San Francisco Bay Regional Water Quality Control Board

February 11, 2022

Subject: Response to Comments on the Sabercat Trail Extension Project Initial Study Mitigated Negative Declaration, SCH No 2022010048

Figure 1: Overlap of Temporary Access Road (red diagonal lines) over Riparian Portion of I-680 Mitigation Area (please also see project drawing attached to this letter)

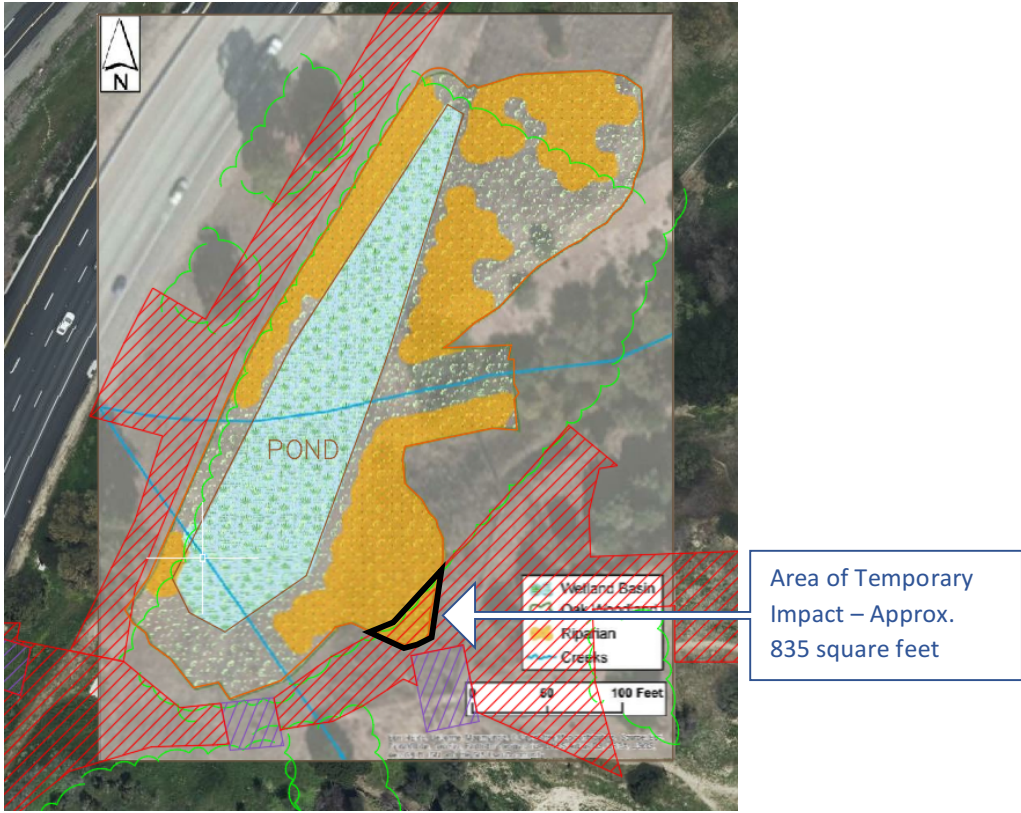
Table 1 - Comment 1. The Project should avoid impacts to the existing Caltrans Sabercat Creek Mitigation Site.

Table with 3 columns: IS/MND Summary Text, RWQCB Commentary, and Response. Row 1: Construction access for the Project may result in impacts to the Caltrans Sabercat Mitigation; The extent of the Caltrans Mitigation is illustrated in Figure 2 of the attached Sabercat Creek Mitigation Project, Annual; Thank you for confirming the boundary of the I-680 Sabercat Creek Mitigation Project. This boundary has not been available via design drawings, but we tried to estimate the boundary using aerial photographs and

<p>Wetland (Caltrans Mitigation), which is located within Caltrans right-of-way east of I-680 and adjacent to Sabercat Historical Park.</p>	<p>Wetland Monitoring Report, Year 6 Wetlands and Waters Restoration (Year 6 Monitoring Report) Caltrans, District 4, December 2017. The areas identified as wetland basin, oak woodland, and riparian in Figure 2 are required for compliance with the Certification. These areas are to be preserved in perpetuity and should not be disturbed by Project activities.</p>	<p>included this boundary into our design drawings to assist in determining avoidance and minimization limits. See figure 1 inserted below and project drawing attached as EX-1.</p> <p>As described in the project description, the Construction Management Plan (CMP) developed for the proposed Project includes a measure to limit the construction footprint to the smallest area possible which would minimize and avoid impacts to the riparian habitat. Additional refinements may be possible that may include avoiding impacts in this area once the geotechnical information becomes available.</p> <p>As noted in the IS/MND, consideration was given to other alternatives. All of which result in substantially greater adverse impacts on the Caltrans Mitigation site and/or riparian and wetland areas within the Sabercat Creek corridor.</p> <p>Resolution: The revised IS/MND will include an exhibit (like Figure 1 inserted below) that delineates the mitigation site as well as the temporary construction limits for both staging and construction access routes.</p>

<p>...because shading of the mitigation wetland would be transitory relative to the sun's arc both seasonally and hourly, there is likely to be no substantive change in the existing conditions. The shading impact is considered less than significant, and no mitigation is required.</p> <p>A portion of the upland zone within the mitigation area is proposed for construction access to build the east landing and would be <u>temporarily impacted</u> during Project construction...despite pursuing other alternatives that would disturb high habitat value ...Therefore, impacts to an upland component of the Caltrans Sabercat Creek Mitigation Site would be considered the <u>least damaging practicable alternative</u>.</p>	<p>1)It is <u>not clear</u> from the discussion of Potential Impact BIO-8 if the impacted uplands would include the oak woodland and riparian areas identified in Figure 2 in the Year 6 Monitoring Report. Please compare the outlines of the oak woodland and riparian areas in Figure 2 to the areas that are proposed for temporary disturbance for construction access for the Project. <u>If there is an overlap</u> between these two areas of upland vegetation at the Caltrans Mitigation site, please attempt to relocate the construction access area out of these Certification-required mitigation areas.</p> <p>2)The MND should be revised to quantify the surface area of unavoidable impacts to the Caltrans Mitigation site and provide sufficient compensatory mitigation for that area of impacts. Since mitigation sites are to be preserved in perpetuity, the required amount of mitigation for impacts to mitigation sites is usually greater than the mitigation quantities required for other impacts.</p>	<p>The area temporarily impacted is estimated to be less than 0.02 acre (estimated to be approximately 830 square feet) and located in the area identified as riparian and oak woodland in Figure 2 in the Year 6 Monitoring Report. The area temporarily impacted is on the edge of the Caltrans Mitigation site (<i>Please refer to the figure 1 below for location of temporary impact</i>).</p> <p>The tree georeferencing survey in the Mitigation Area did not find any surviving trees within the temporary impact area. However, because the overgrowth may have shielded sightings, the Project team is erring that up to 6 oak saplings, as well as Coyote brush, California sage, and black sage vegetation may be impacted. The Caltrans Mitigation site requirements per condition 12 of the original 1602 permit (<i>and thus not called out as mitigation</i>) include:</p> <ul style="list-style-type: none"> • Full restoration of any disturbed areas, • A 6:1 replacement ratio of tree plantings that are not oak trees, and • An 8:1 replacement ratio of any oak tree removed <p>Please note that because the mitigation site is supported with these replacement obligations, the mitigation listed in the IS/MND only addresses the coordination with Caltrans on the restoration and location of the tree replacement. Neither activity would become a new impact because restoration will occur in situ and tree plantings will only require workers with hand shovels/tools planting within the I-680 Mitigation site boundaries. These efforts would not result in the need for large equipment, nor will there be clearing, grubbing or access impacts since the Caltrans Mitigation site has designated access routes.</p>
